From: Hayden Ausland
Sent: Thursday, December 10, 2020 10:58 AM
To: 'grluci@gmail.com'; Kim McMillan
Cc: 'JWLuci@gmail.com'; Tabitha Boschetti; Steve Koper
Subject: RE: Stormwater Master Plan - Public Comment Period

From: G Lucini <grluci@gmail.com>
Sent: Monday, December 7, 2020 3:43 PM
To: Hayden Ausland <hausland@tualatin.gov>; Kim McMillan <kmcmillan@tualatin.gov>
Cc: John Lucini <JWLuci@gmail.com>
Subject: Re: Stormwater Master Plan - Public Comment Period

I understand the City is providing a Citizen Comment period ending December 15th. And I understand the proposed Master Plan will then be presented to the Planning Commission, and then to the City Council for adoption into the City's governing documents.

Figure 9. IMPLEMENTED County Subbasins - Erroneous Boundaries for Drainage above the Lucini Property.

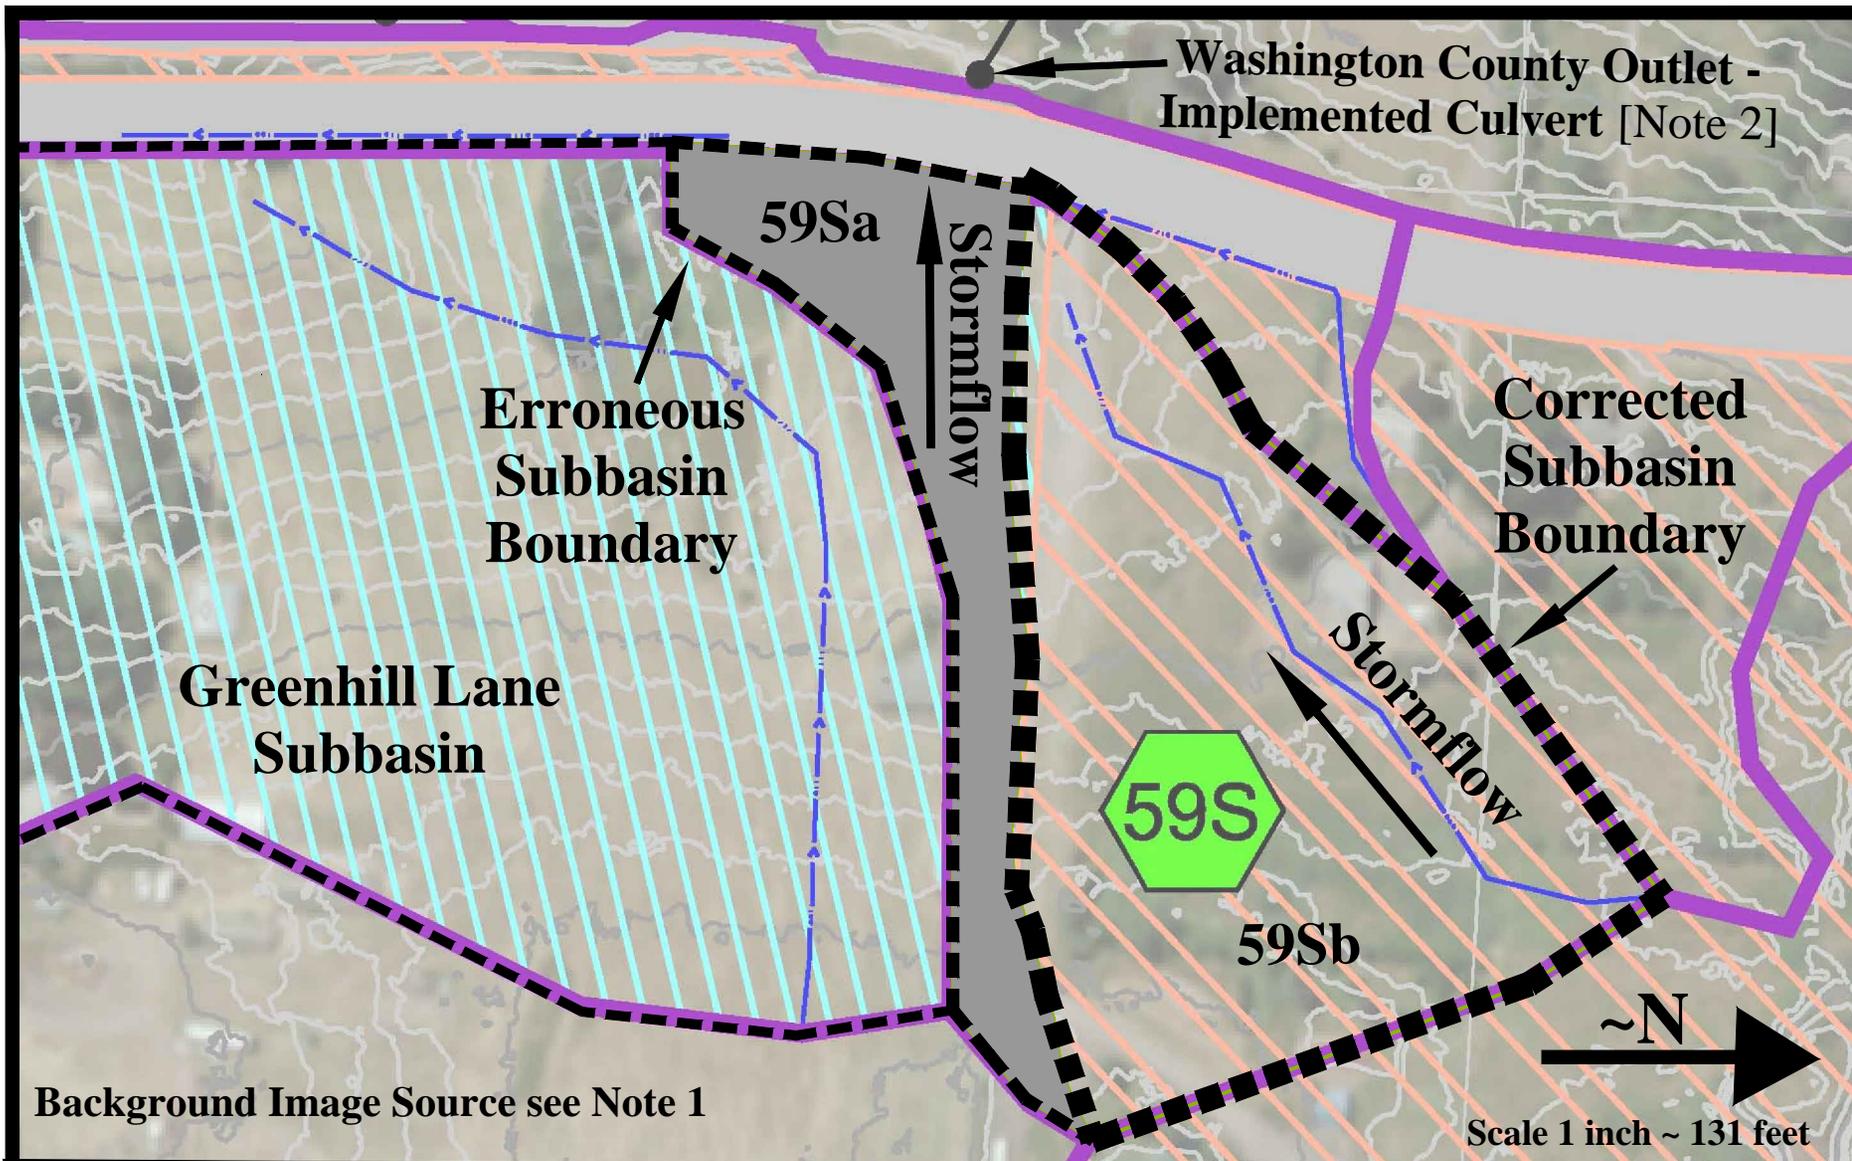
Stormflow values are graphically compared in the Figure 6 through Figure 8 column charts. Figures 9 and 10 show the subbasin boundaries for IMPLEMENTED conditions, which permanently re-rout stormflows from a portion of the Greenhill Lane subbasin ultimately onto the Lucini property

Defective County Topography and Inaccurate Original Curb and Storm Sewer Claims
Stormflows originally directed south into the Greenhill Lane subbasin, through the road right-of-way, were re-routed by the road improvement project onto the Lucini property via the County's Storm Outfall #5. As shown in Figures 4 and 5, the subbasin drainage drawings for the ORIGINAL conditions¹⁹ do not show the actual topography affecting drainage conditions. The IMPLEMENTED drainage basin conditions then re-route increased storm flows to the Lucini property.²⁰

Figure 11. County Existing Plan Drawings with Annotations Highlighting the ORIGINAL Conditions and Piping

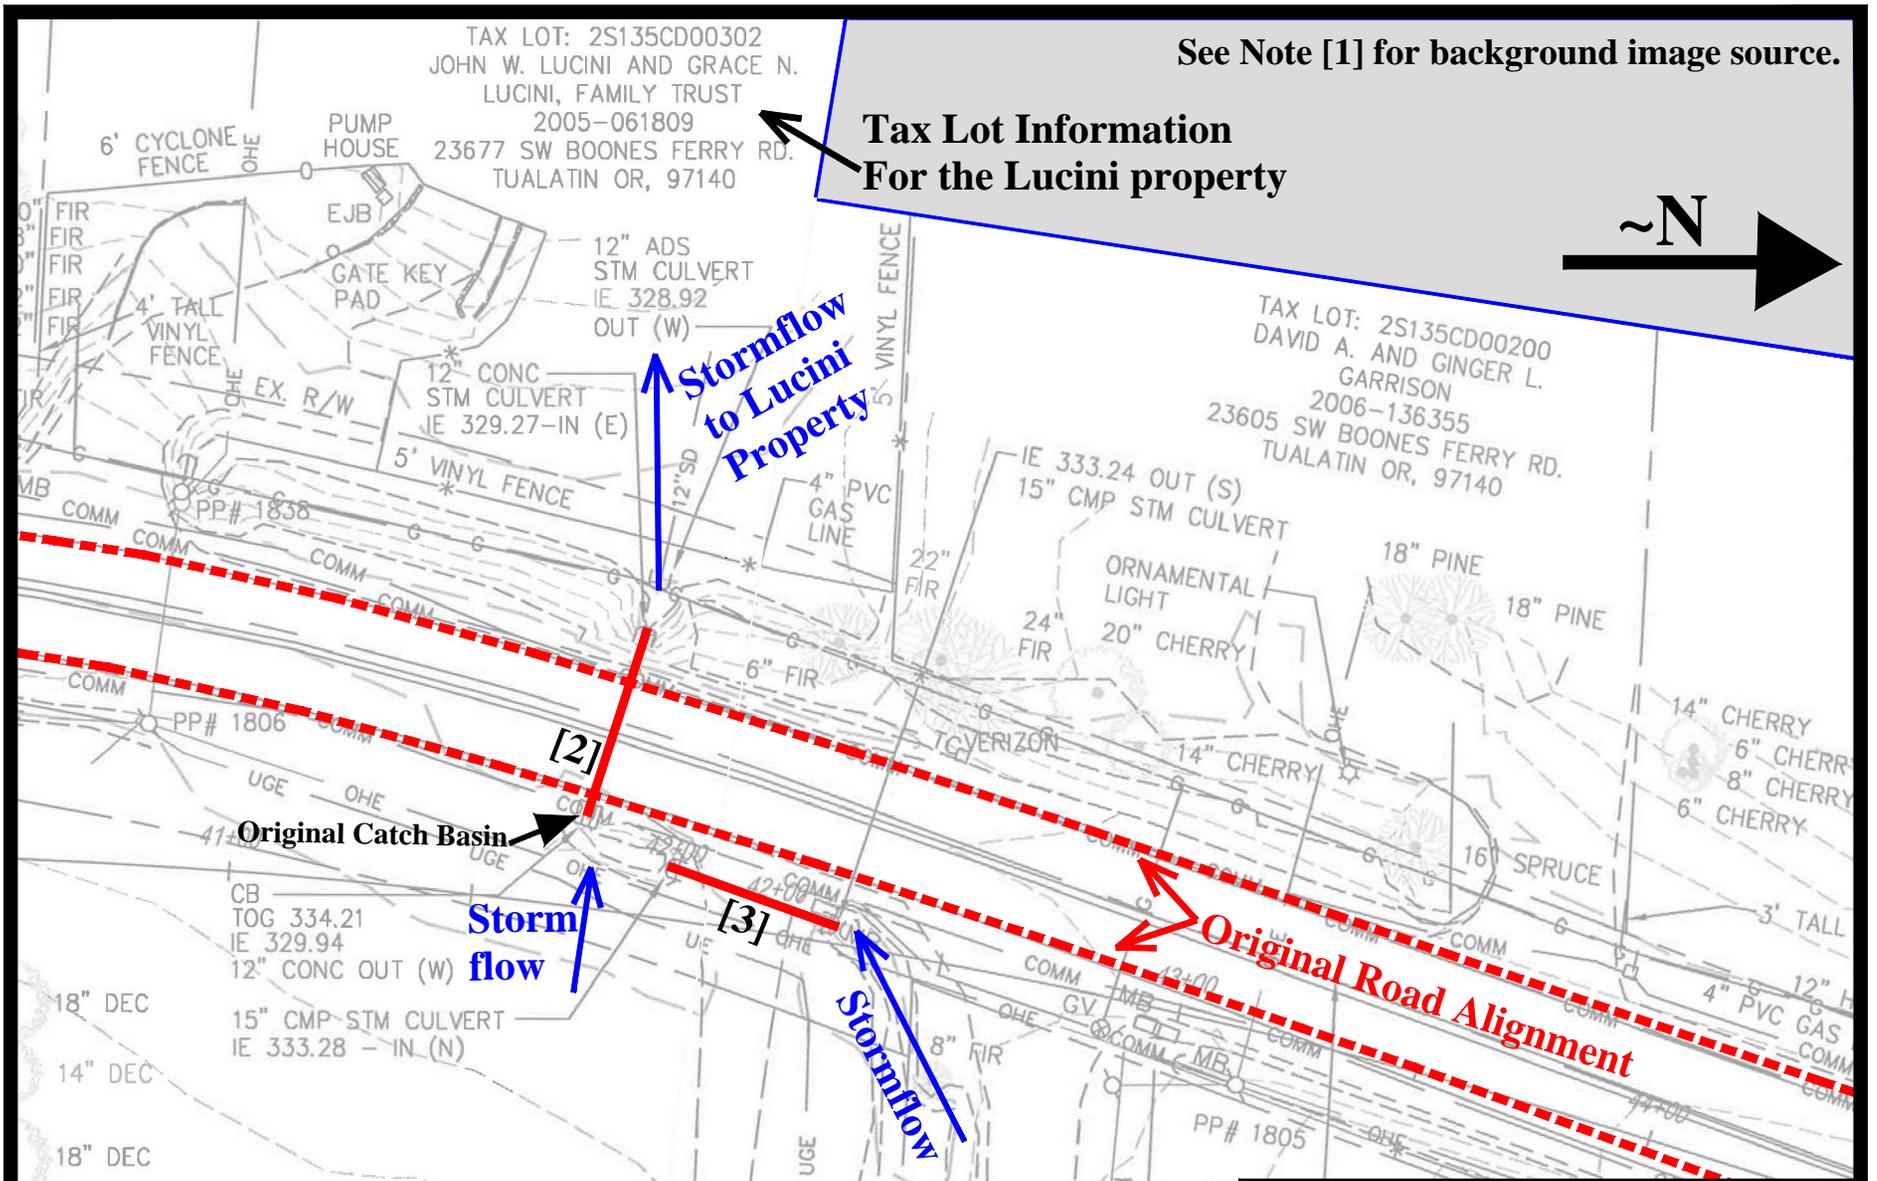
Figure 11 shows the hydraulic conditions for connecting piping and the original road culvert locations for the ORIGINAL configuration. Figure 12 illustrates the IMPLEMENTED hydraulic conditions consisting of connecting piping and the new culvert comprising the County's Outfall #5. Figure 12 also shows the juxtaposition of the old and new Boones Ferry Road that hydraulically affects flows to the Lucini property.

The County's Drainage Report says that the original road had curbs and storm sewers routing flows.²¹ This is incorrect as there were no curbs or storm sewers for SW Boones Ferry Road above the Lucini property. Drawings 2C-7 and 2C-8 excerpted in Appendix C demonstrate there were no curbs and storm sewers upstream of the Lucini property.²² Additionally, the photos in Appendix A1 taken by as part of the County's Wetland Delineation Report²³ and by the Lucini's also reveal the lack of curbs and storm sewers above the Lucini property. This is a crucial detail because it determines whether a portion of stormflows go south into the Greenhill Lane subbasin, or north into the subbasin above the Lucini property. In its Drainage Report the County erroneously claims that a portion of the Greenhill Lane subbasin stormwater drains into the Lucini property.

Figure 12. County Existing Plan Drawings with Annotations Highlighting the IMPLENTED Piping Conditions

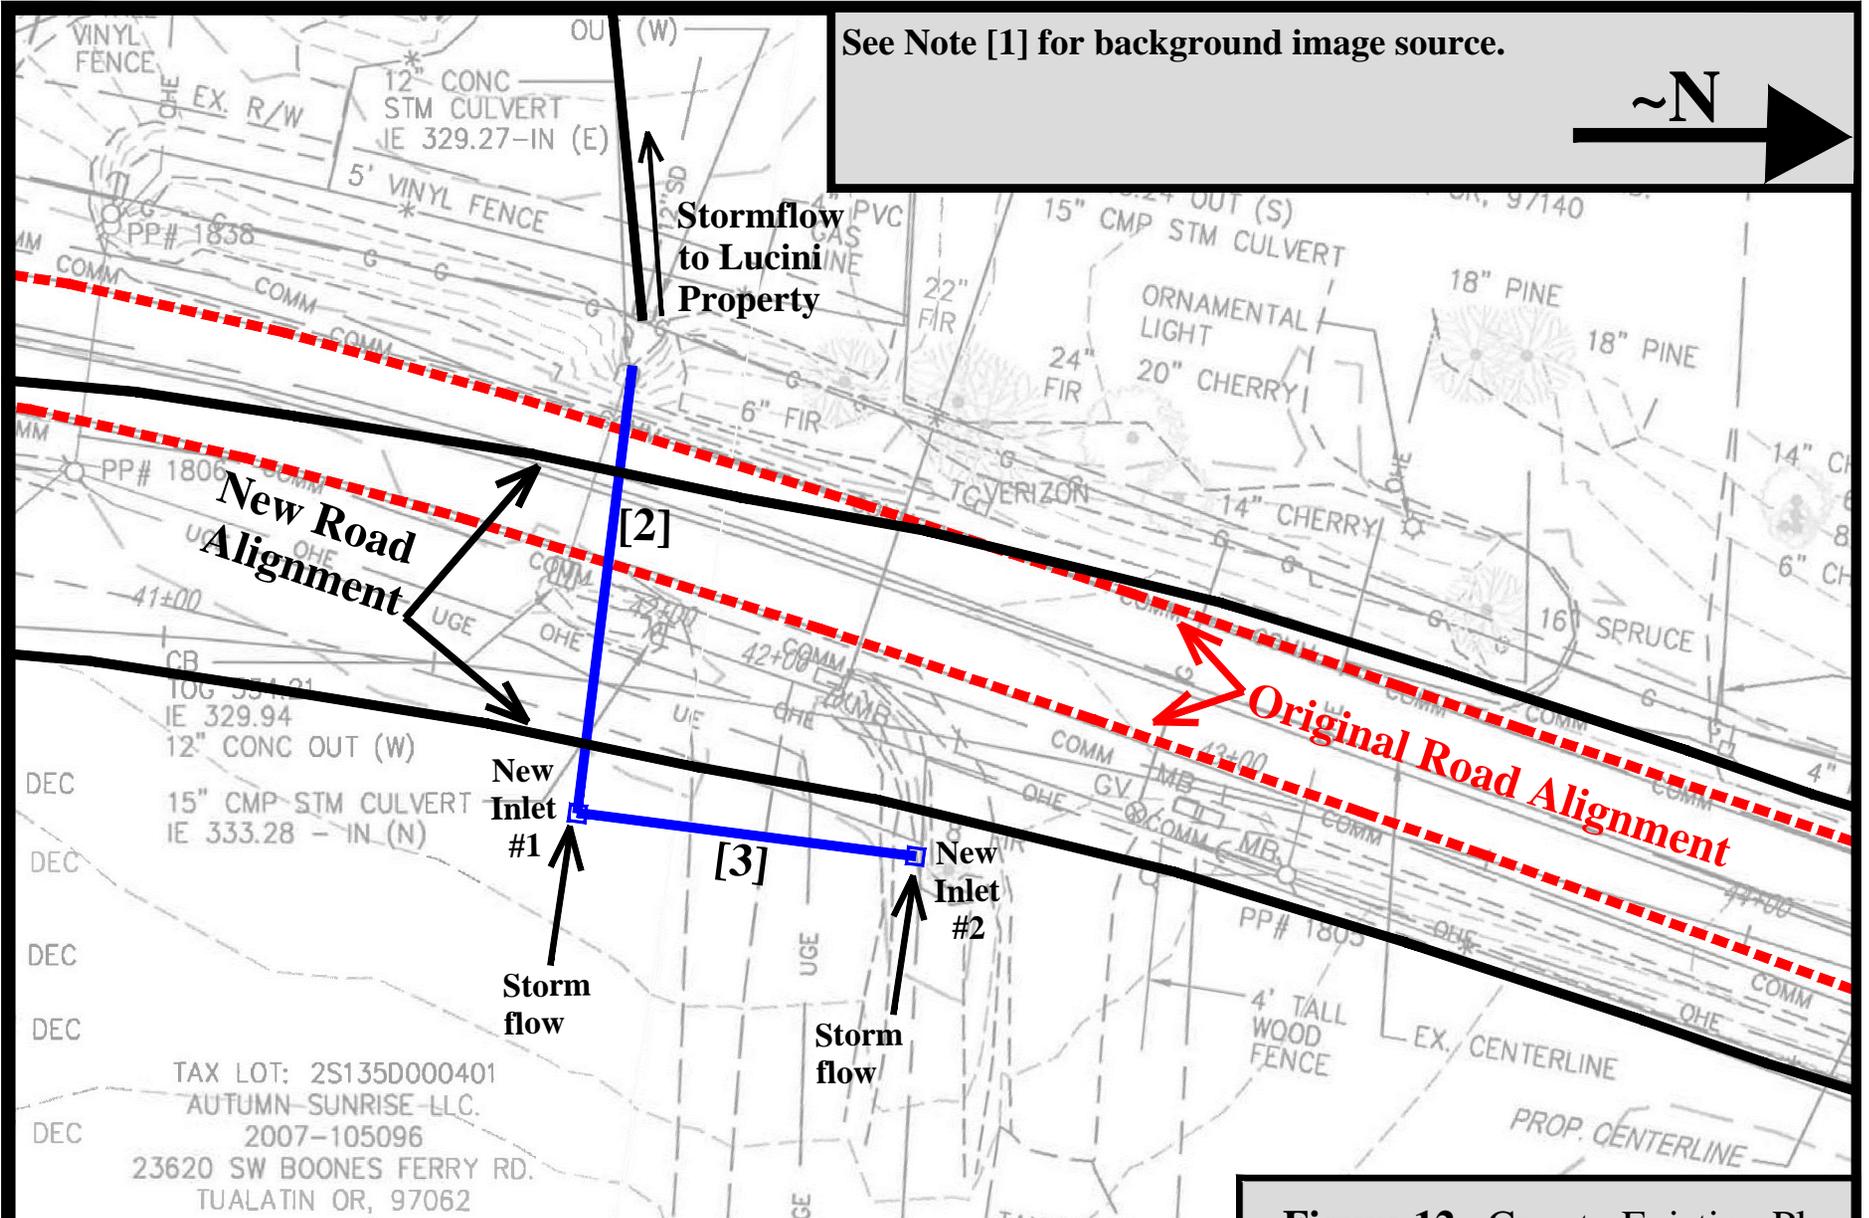
The County provided storm grates on its two new stormwater inlets in the subbasin above the Lucini property as shown in Figure 12. The County neglected to provide a storm grate for the pipe entrance to the Lucini property (see Figure 12). The Lucini property drainage receives stormwater passing through SW Boones Ferry Road culvert (Outfall #5). The County supposed that its generated stormflow will be conveyed successfully through the Lucini property. The Corps HEC-HMS and HEC-RAS demonstrate that this is not the case for the 25-year design storm cases presented in this analysis.

An orifice plate can be used to reduce storm pipe flow diameter and flow area during peak flow events. This physical measure decreases peak stormflows and lowers storm flow velocities on the Lucini property. The location of the proposed orifice plate is shown in Figure 12 as indicated in the IMPLEMENTED new storm inlet #1.

This remedy alleviates the immediate problem on a short-term basis by reducing peak stormflows and consequent erosion on the Lucini property. This can be accomplished by using an orifice plate at the County's New Inlet #1 (this is the south inlet). The proposed orifice location is shown in Figure 12 at the New Inlet #1. The orifice would be installed at the upstream end of the implemented 80-foot long, 12-inch diameter culvert comprising the County's Outfall #5.

The County has indicated it is using CWS 2007 for guidance, which contains: Drawing No. 270 “Flow Control Structure Detail” that can be installed at the New Inlet #1 location; and Drawing No. 240 “Water Quality Manhole (Mechanical)” that can be installed just upstream of the Lucini property pipe entrance. For convenience, CWS Drawing Nos. 270 and 240 are contained in Appendix G of this report. See Figure 12 for the locations of these proposed flow and water quality control facilities.

Figure 16. ORIGINAL Configuration - Velocities at Likely Flows 25-yr Design Storm Event
Upstream and Downstream Stations along the Lucini property approximate 150-foot Ditch

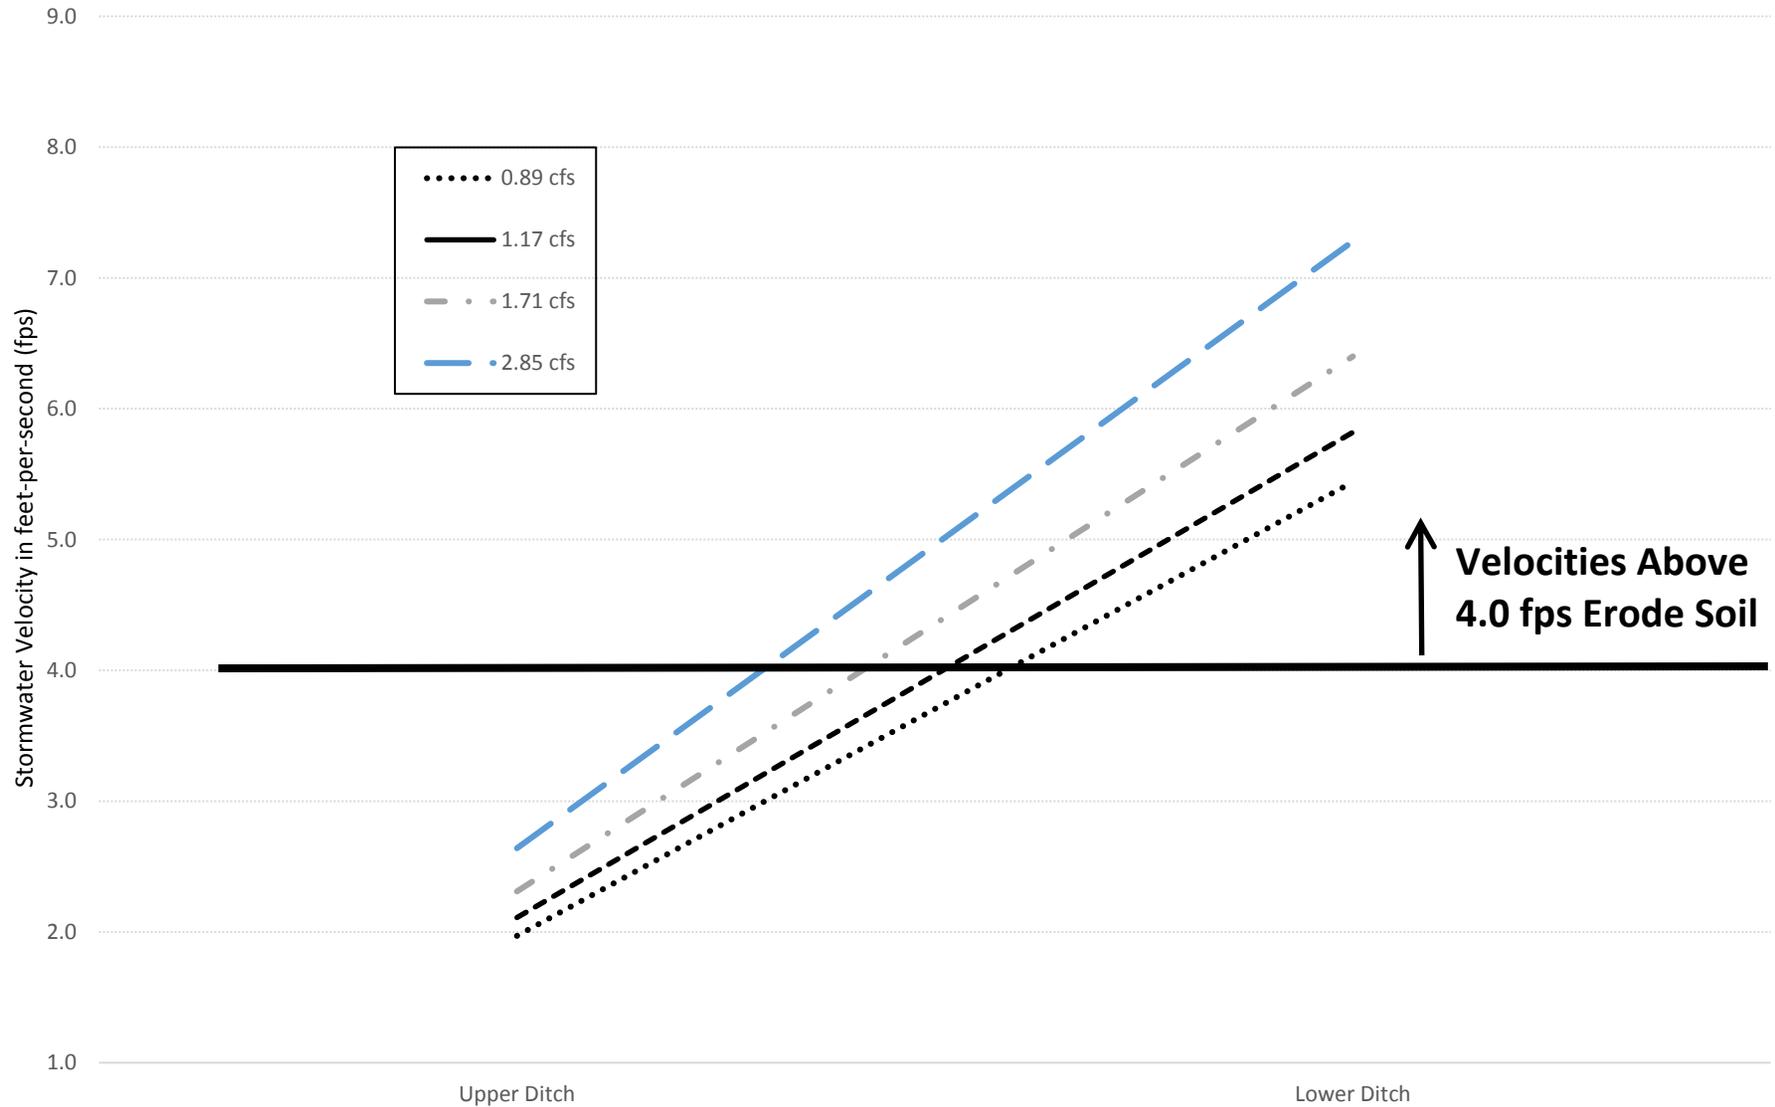
Stormflow velocities shown in Figure 16, for a range of land use conditions and the ORIGINAL subbasin configuration, demonstrate many instances where values exceed velocities that cause erosion on the Lucini property. These velocities exceed 4.0 feet-per-second (fps) and cannot be maintained. This deleterious situation requires measures to reduce peak flows coming through the County's culvert (Outfall #5) and onto the Lucini property. The physical conditions of excessive and increased streamflow on steep slopes existing on the Lucini property, and compared to the ORIGINAL conditions, were not evaluated by the County in its Drainage Report.

Figure 16 for the ORIGINAL configuration illustrates velocities for the upstream and downstream stations along the Lucini property approximate 150-foot ditch²⁷. This figure shows that as stormflows increase from 0.89 cfs to 2.85 cfs, highly erosive storm velocities occur.

As charted in Figure 16, flow velocities in excess of 4.0 feet-per-second (fps) produce adverse conditions that erode soil.²⁸ This is consistent with the stormwater damage to the ditches, and pipe blockage, on the Lucini property (see photos in Appendix A2).
